CITY OF ALBUQUERQUE

Re: McMahon Market Place New Shell Building
5708 McMahon Blvd. NW
Request for Temporary 30-Day CO – Accepted
Engineer's Stamp dated: 6-30-16 (A11D001E)
Certification dated: 2-6-17

COVERED SIDEWALK CULVERT

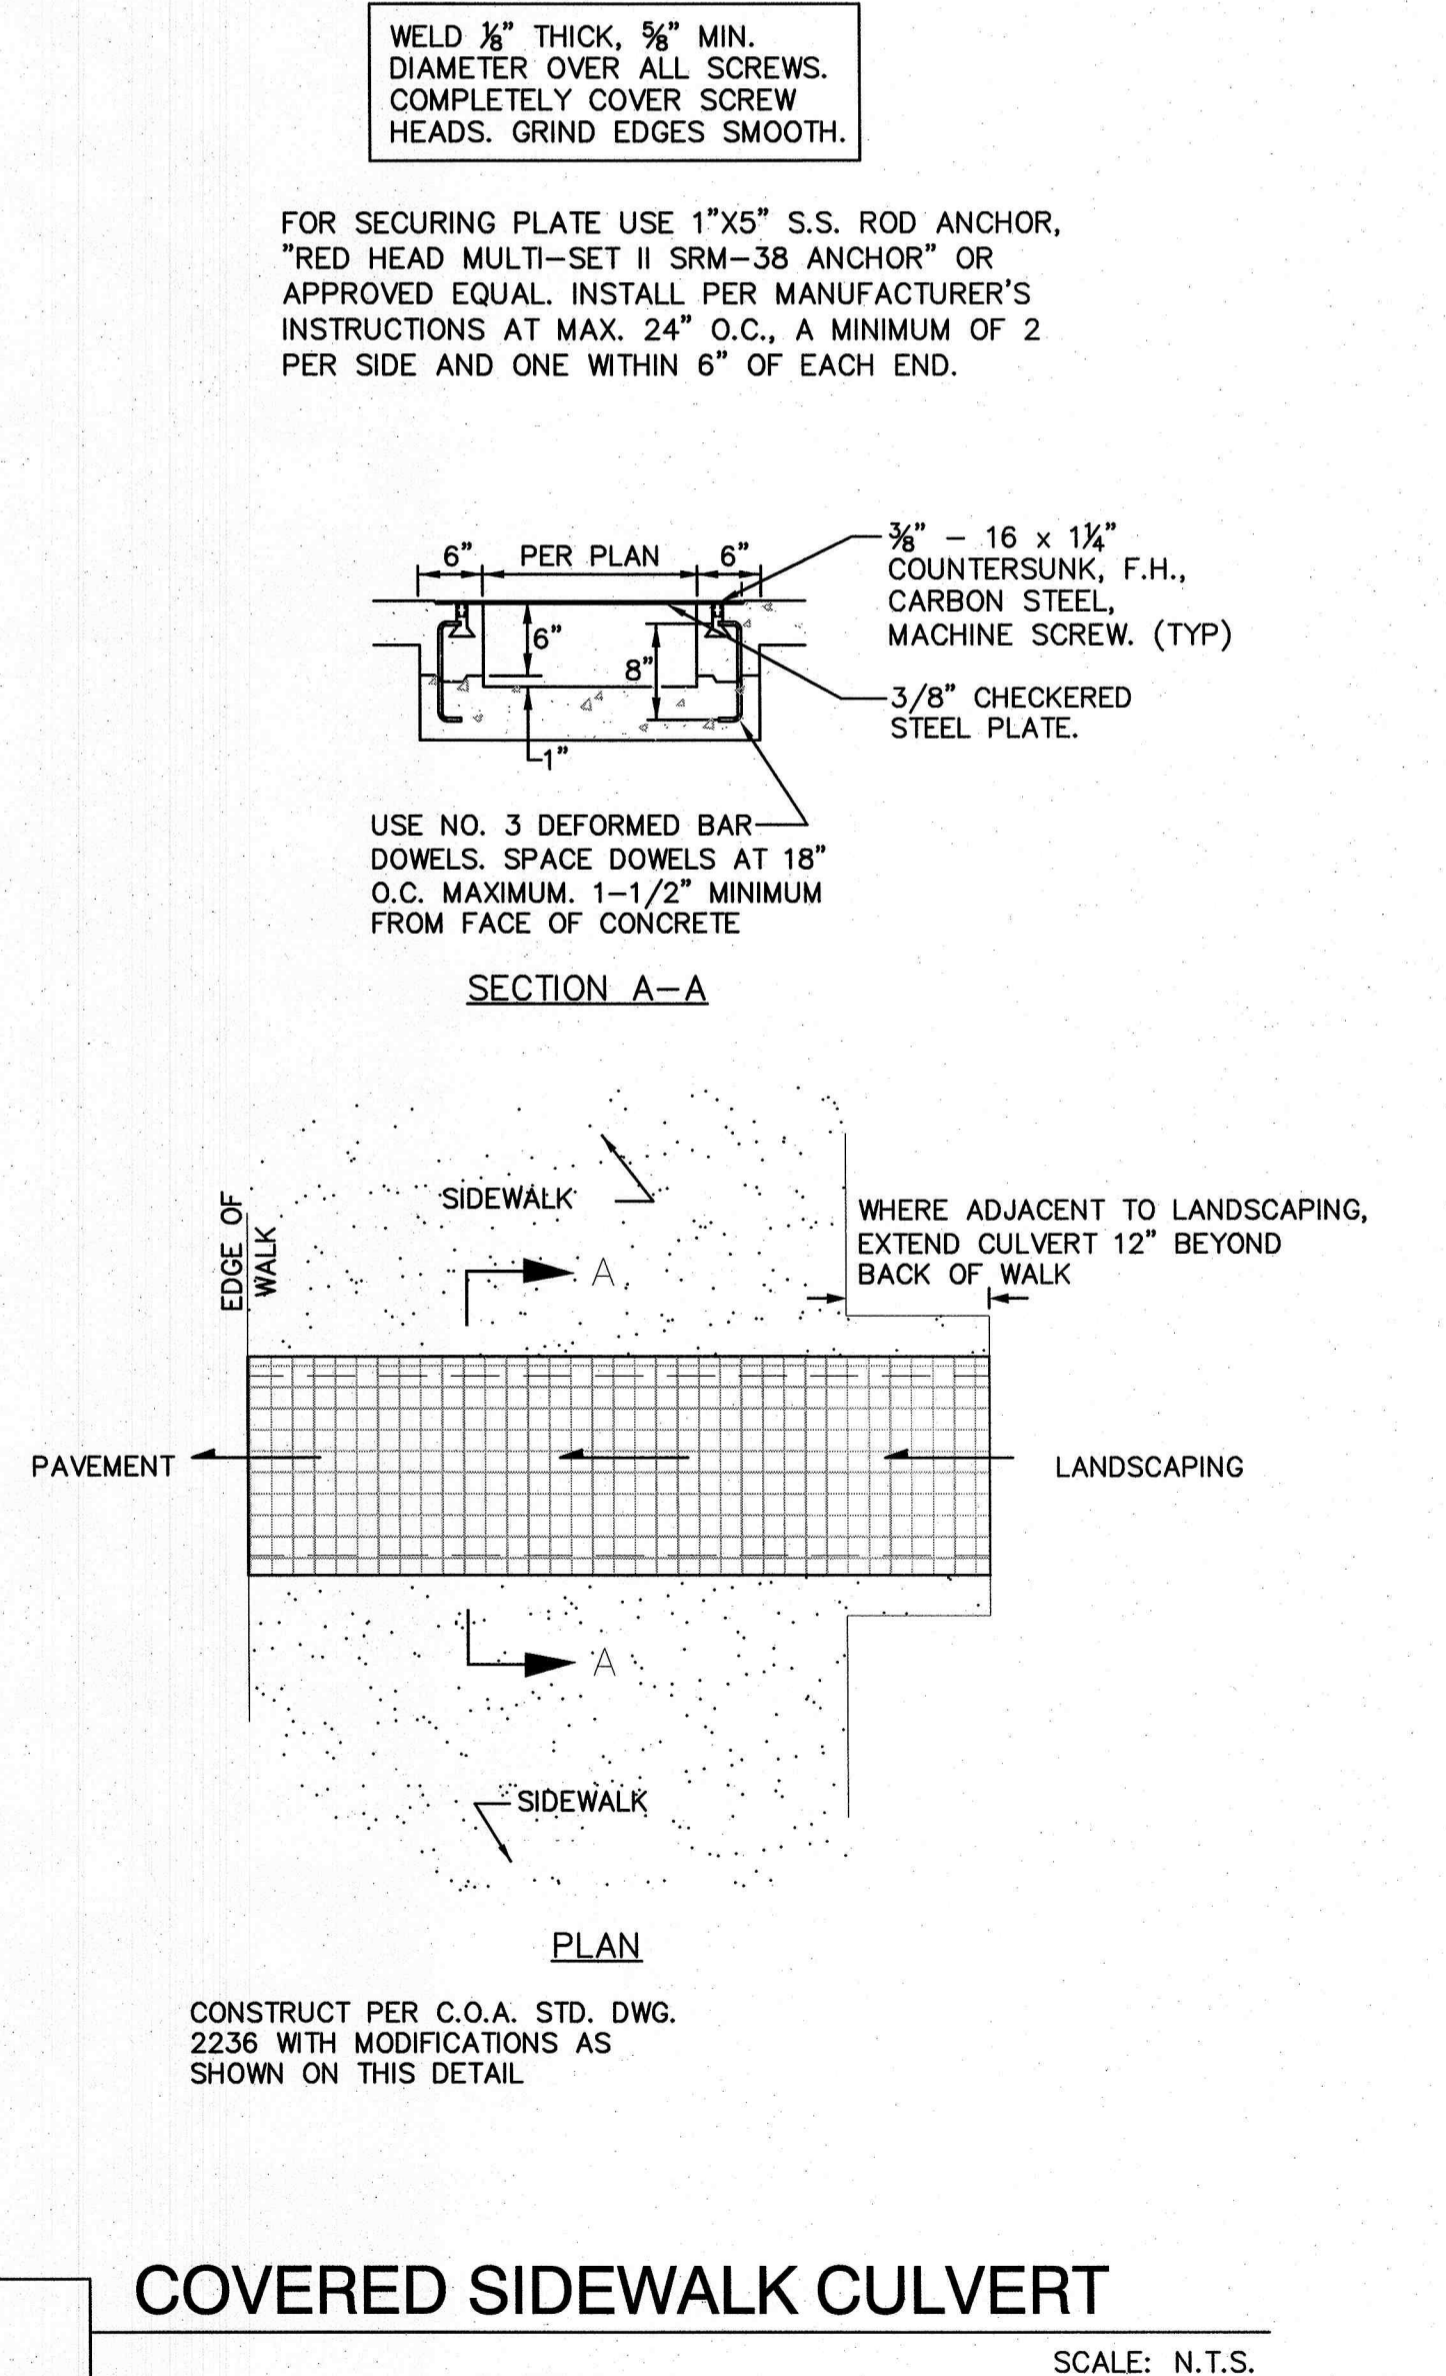
- The sidewalk culvert must be a monolithic pour.
